DATE: September 20, 2010

SUBJECT: IDAHO STATE UNIVERSITY – NRC NON-ROUTINE INSPECTION REPORT  
NO. 50-284/2010-201 – Reply to March 9, 2010 Findings - Part 1 of 5

Photos showing easy roof access the outside of the reactor room, taken June 20, 2010.

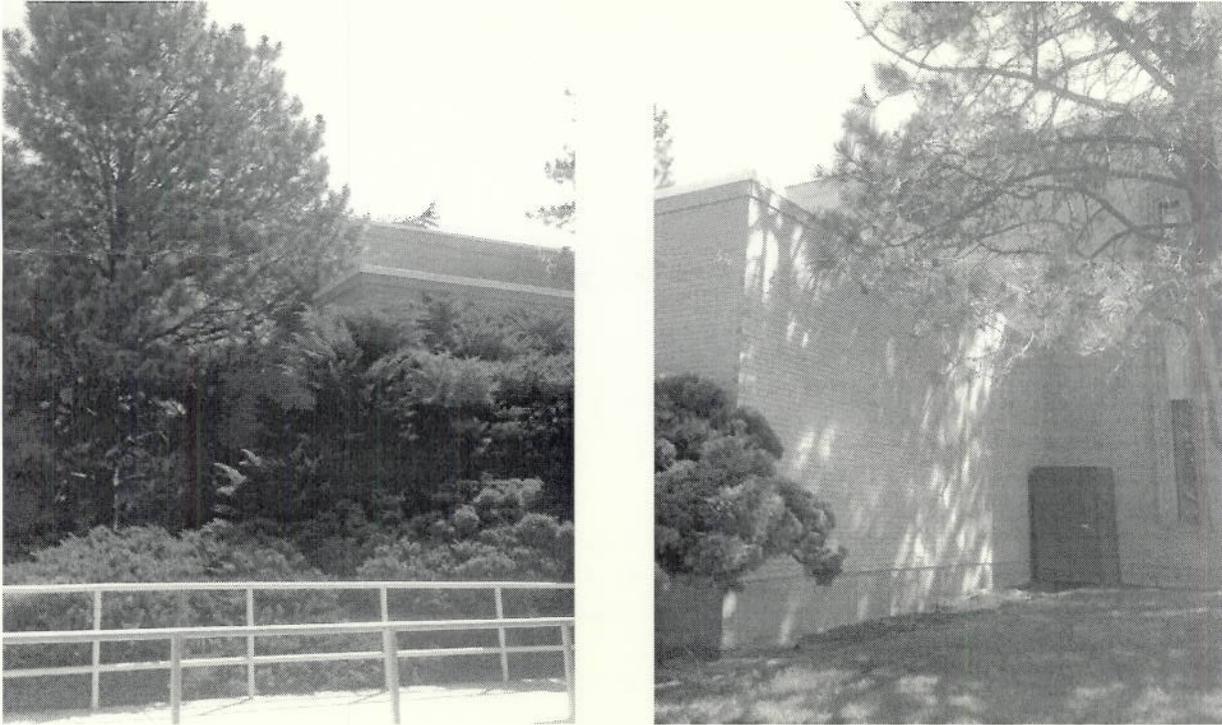
The June 26, 2009 petition letter does NOT state that either a) the failure to conduct a 50.59 review or b) the existence of a modified roof access “allowed random student access to the roof of the reactor room.” This statement is just plain silly and is beneath the level of a professional engineer. The June 25, 2009 petition letter did state that anyone has easy access to the roof. That is a fact demonstrated by the photographs below taken on June 20, 2010. Not only is there easy access on one side without so much as a ladder, by climbing on the maintenance shack, but also on the other side access is concealed and assisted by a tree. The June 26, 2009 petition did state that once access to the roof has been gained, all of the subsequent activities on the roof are concealed with a 3-foot barrier around the roof. It then becomes very easy to open the hatch or the siphon breaker door at leisure without any worry of being detected. There is no monitoring whatsoever. I know because I was responsible for this facility and satisfactorily passed the senior licensing exam!

Also, the hatch ladder interior to the reactor room is a violation of OSHA requirements to have safety guards to enclose personnel access above one story, particularly at the top of the ladder where personnel must hold a ladder rung with

one hand while fumbling with the keys to unlock the hatch with the other hand, all at a height of 2 stories above the reactor room floor. I will agree that OSHA regulations are not the concern of the NRC, but clearly the NRC inspectors have no concern for the safety of operations staff and facility visitors. That is precisely the root cause of why the facility is among the most dangerous facilities in the country.
